LiDAR Quality Assessment Report

MS_Washington-Choctaw_2014

NGTOC
2015-04-17

Checkpoint Distribution Image

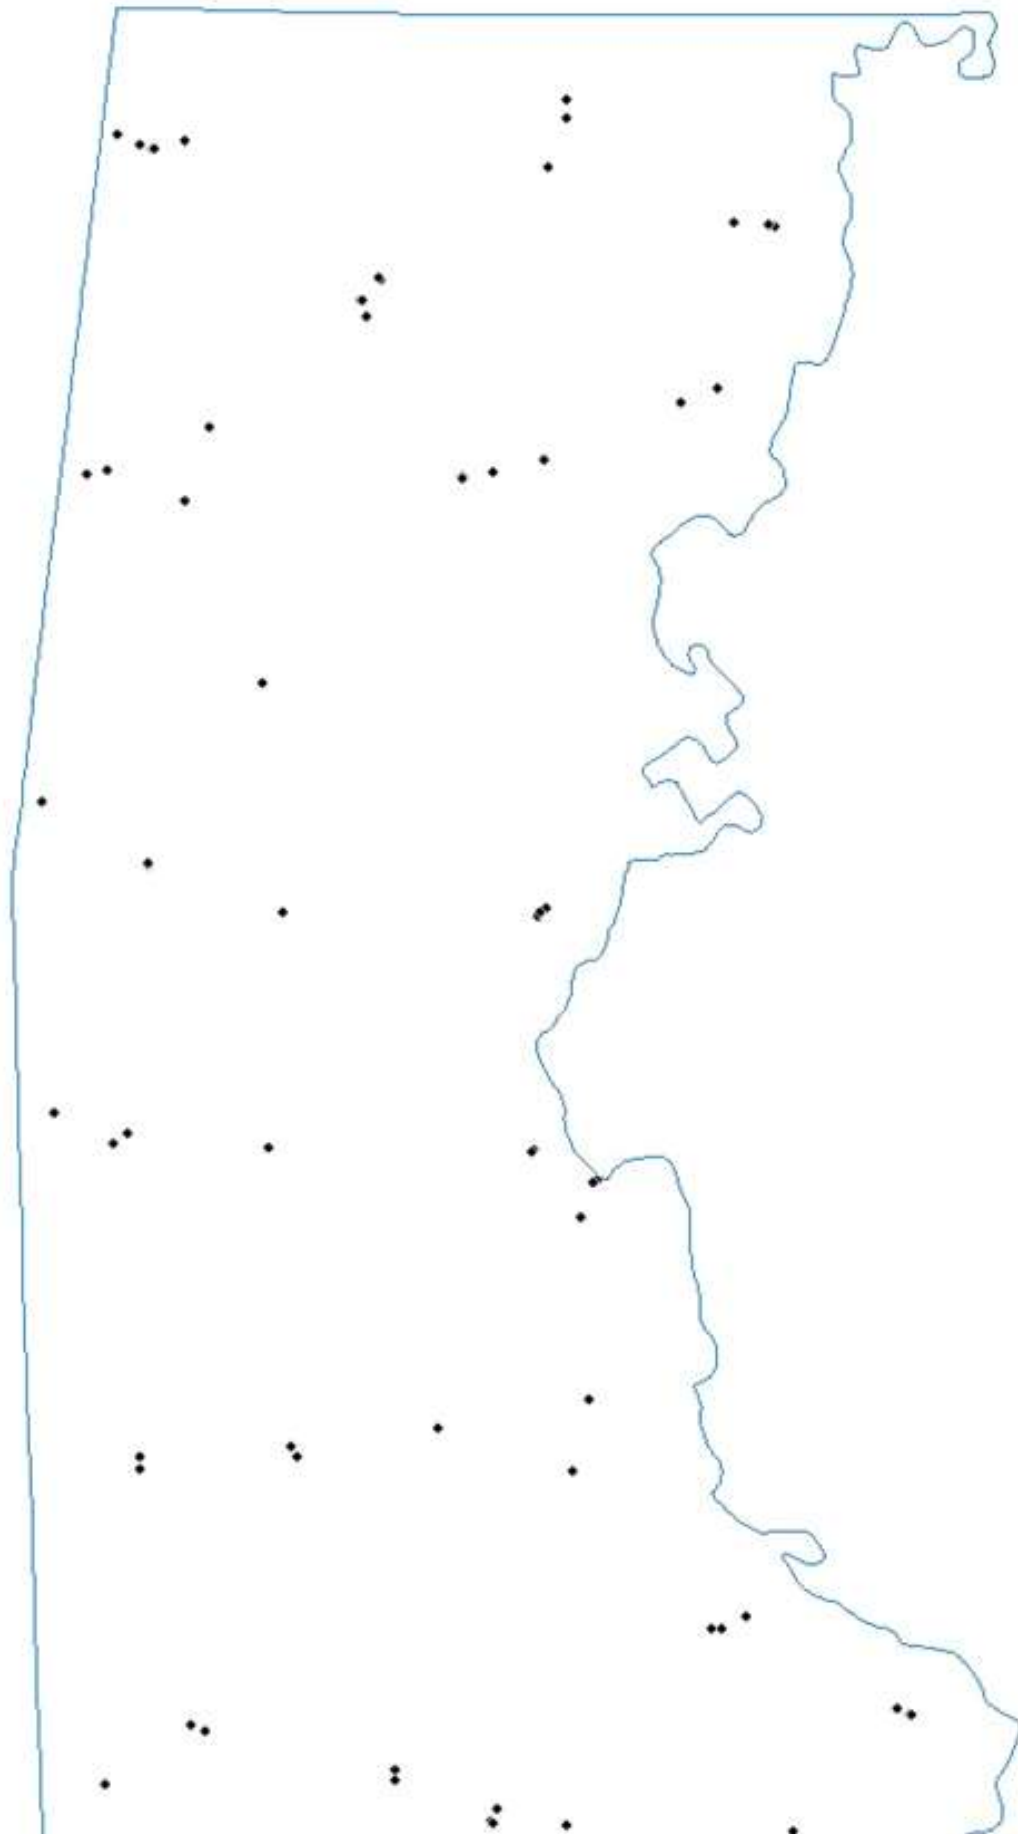
1- The original project (MS_Laurel_2014) divided into two separate projects (MS_Laurel_2014 & MS_Washington-Choctaw_2014) with QA Report for each.

2- Vertical accuracy processed for each project individually, which explains the discrepancy between the reviewed and reported vertical accuracy in values of FVA, SVA, CVA and numbers of check points for the classes.

3- SVA of **Forested Class = 30.0, accepted based on vertical accuracy passing of FVA, CVA and SVA of MS_Laurel_2014 and the FVA, CVA and the rest of the classes of MS_Washington-Choctaw_2014.**

Based on this review, the USGS accepts the vertical accuracy.

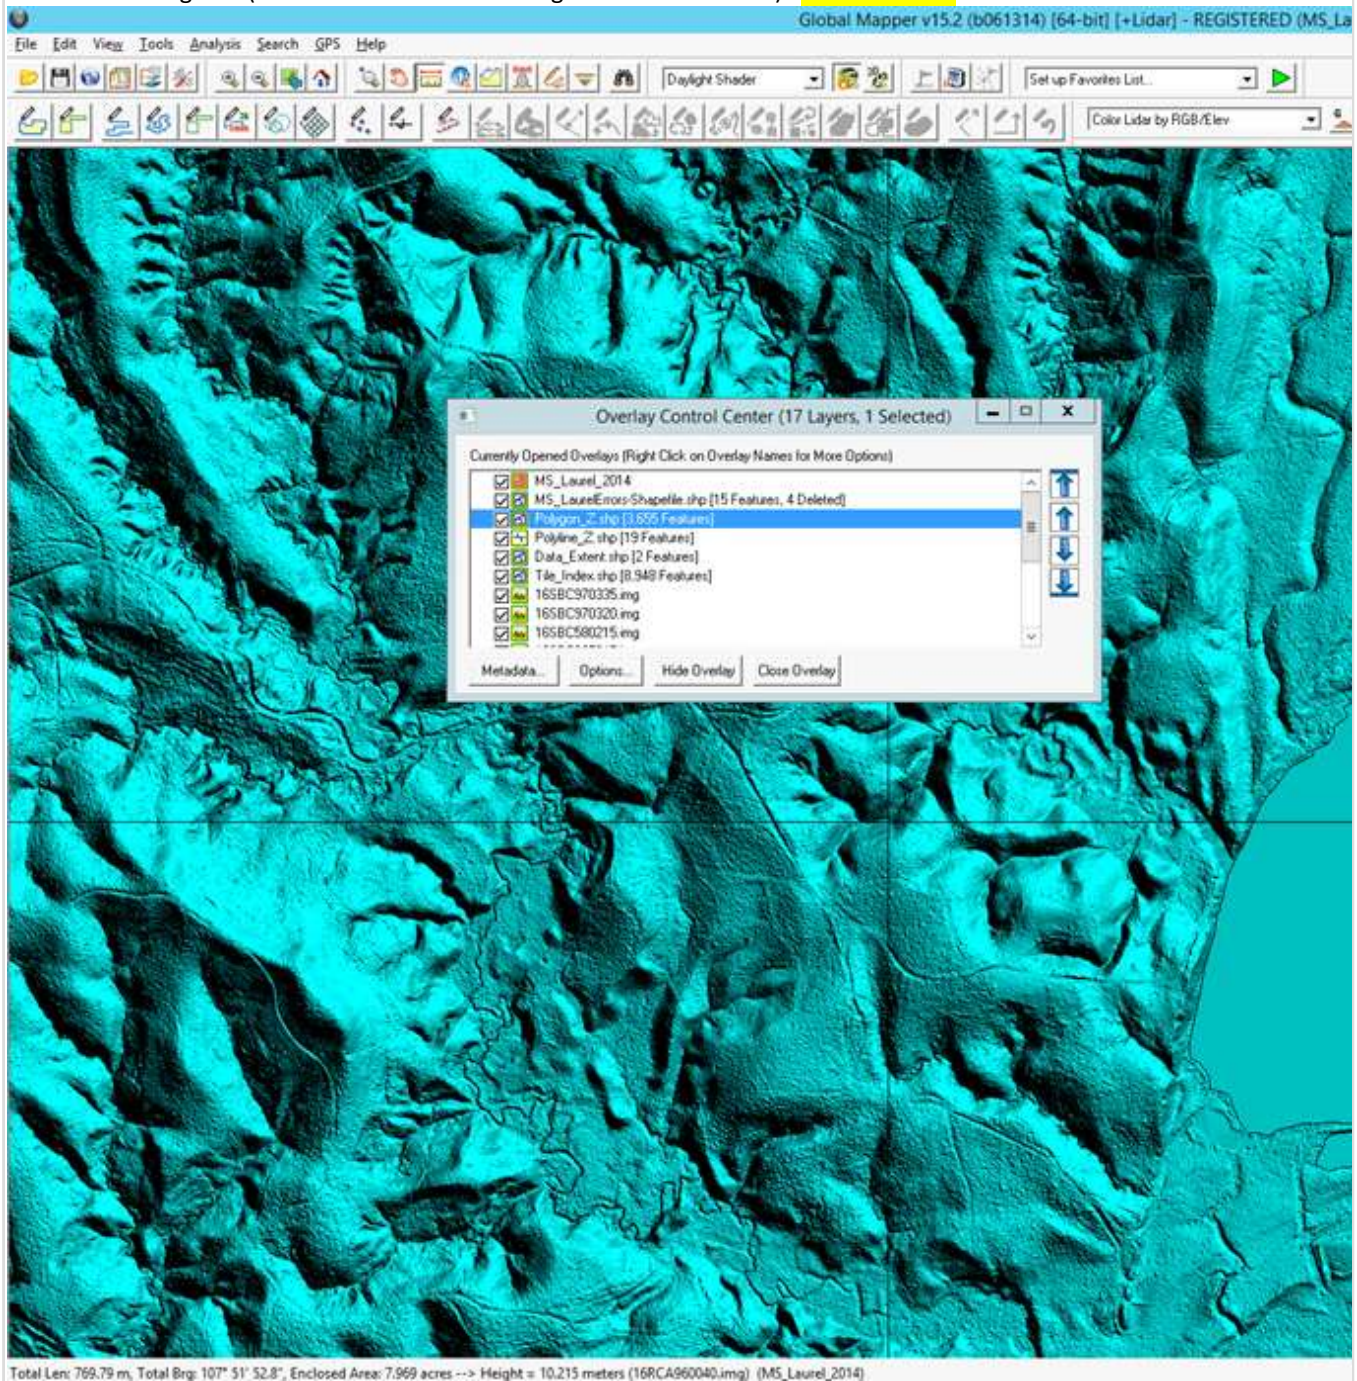
Lake accepted as swamp (shown in intensity images), based on conference call: 04-03-2015

Lake 7.969 Acres not hydroflattened

Missed flattening lake (See waterbodies 2 Acers or greater are flattened) - **Error not fixed**

Based on this review, the USGS accepts the breakline files.

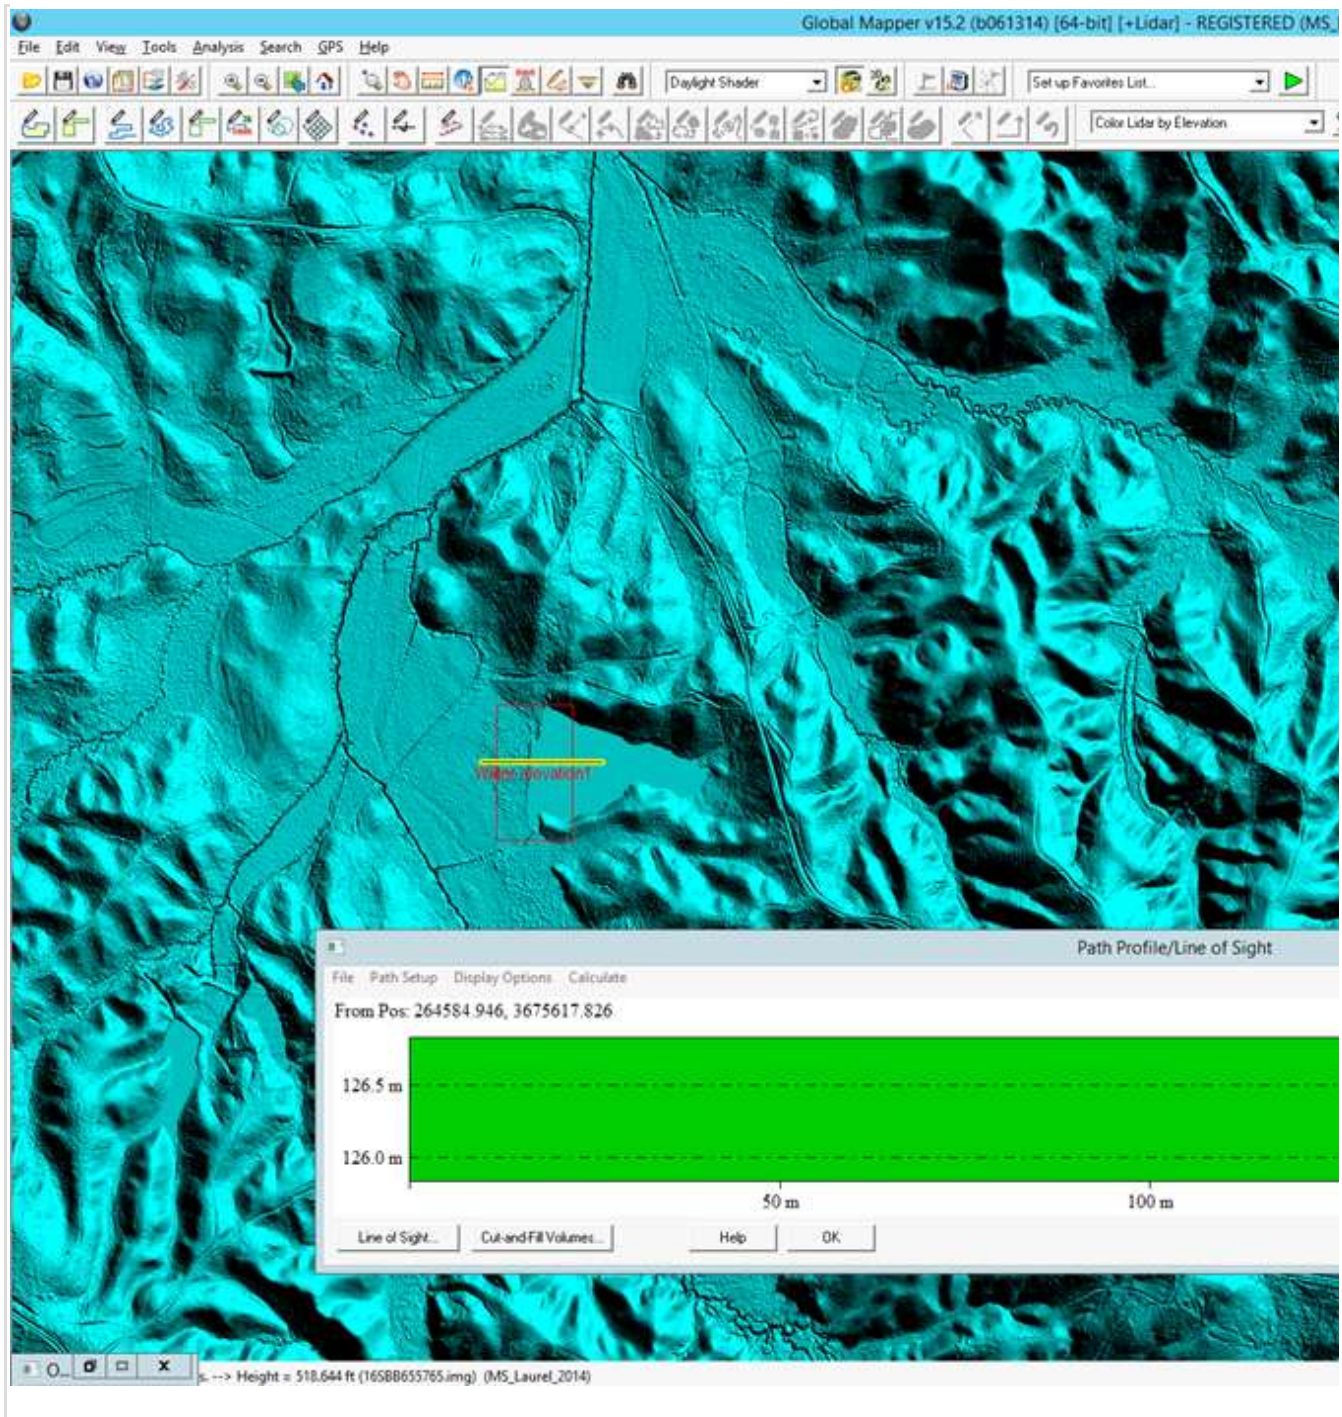
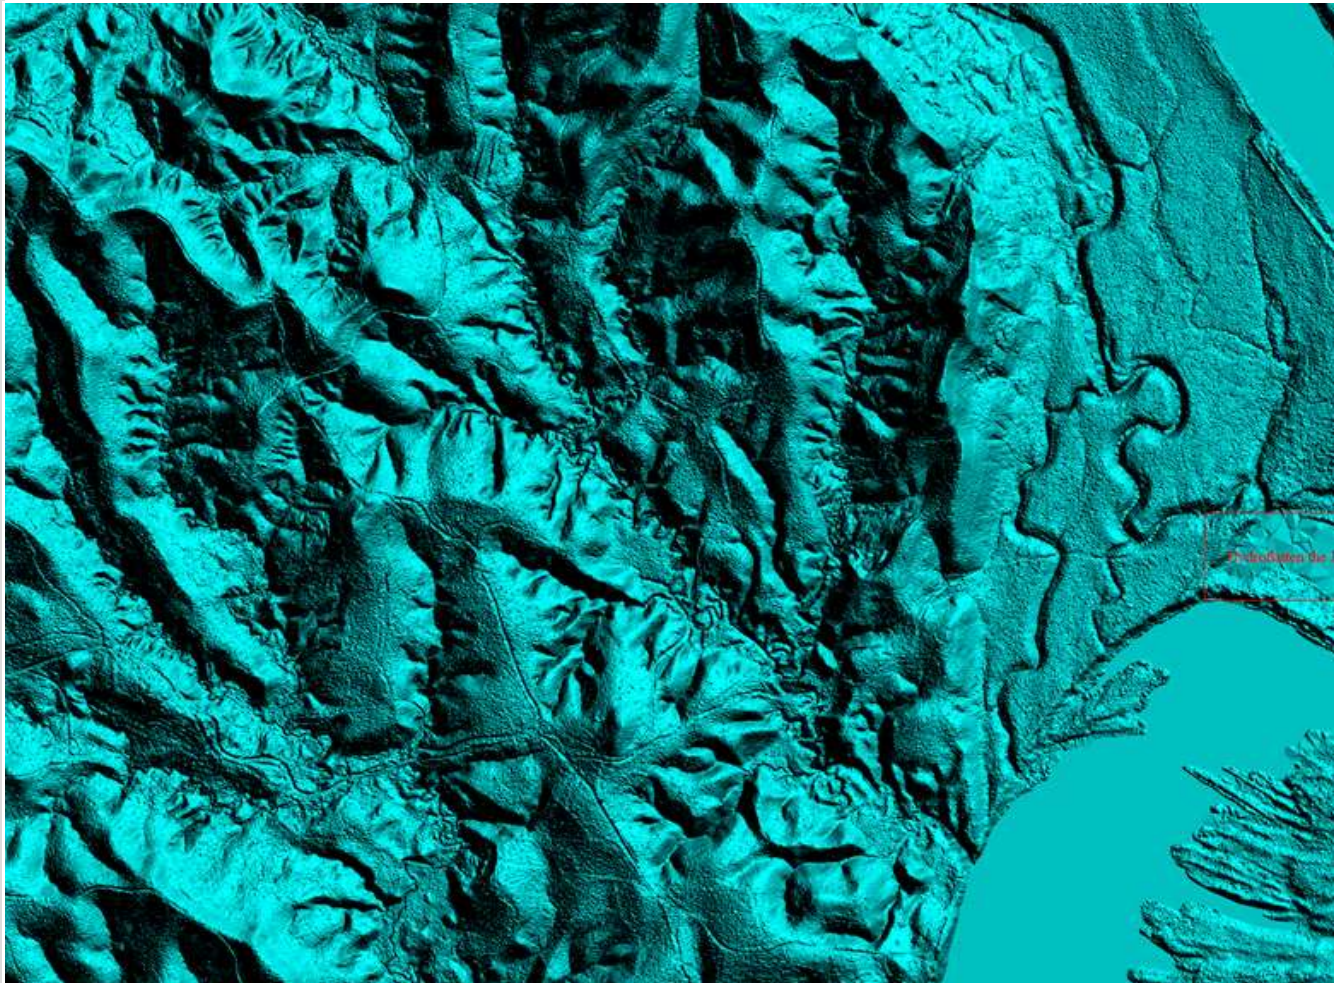
DEM tiles are properly Hydro Flattened ☐ Yes ☒ No

Lake accepted as swamp as shown in intensity images (Conference call: 04-03-2015)

Errors of floating water, and missed hydroflattening of a lake
